# PRE-BID CLARIFICATION FORM

PROJECT NAME:		FILLMORE HIGH SCHOOL NEW ATHLETIC COMPLEX	
PROJECT NUMBER:		Project No. 2024-017 / DSA #03-123950	
TO:		RJ Stump Fillmore Unified School Dist.  Roy Frey WestGroup Designs	
		EMAIL: <a href="mailto:rj.stump@fillmoreusd.org">rj.stump@fillmoreusd.org</a>  <a href="mailto:royf@westgroupdesigns.com">royf@westgroupdesigns.com</a>	
DATE:	01/30/25		
FROM:	AMG & Associates Inc David Silva 661-251-7401	EMAIL:	<a href="mailto:estimating@amgassociatesinc.com">estimating@amgassociatesinc.com</a>
DOCUMENT/DIVISION NUMBER:	096500	DRAWING NUMBER:	A2-3.1

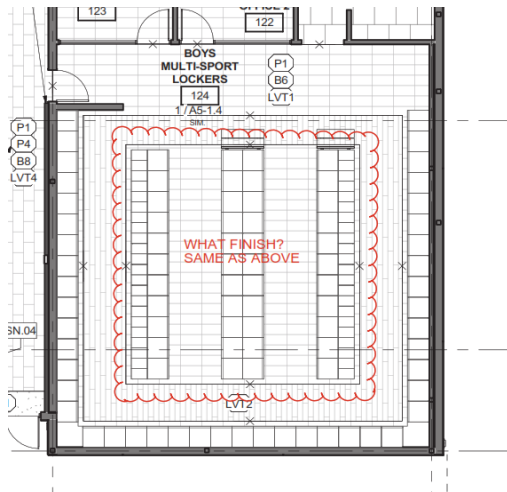
What is the floor finish between the boys lockers (124)?

Floor finish between the boy's lockers is LVT1.
